# Product Change Notification (PCN)

PCN #: 8G-2023

DATE: August 11, 2023

### 4 ANTICIPATED IMPACT OF THE CHANGE:

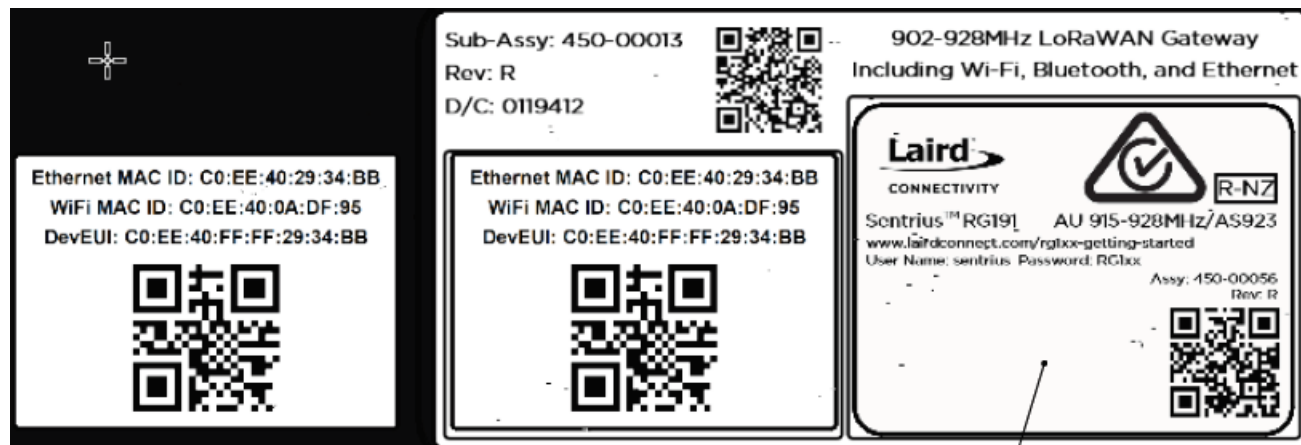
- The OUI change has no hardware or electrical impact on the devices.
- Labeling of the devices utilizing the new OUI (B0FB15) will change. The change is to replace the old OUI with the new one. Examples, by product, are shown in section 5 of the PCN.
- New features and bug improvements as per release notes, linked above
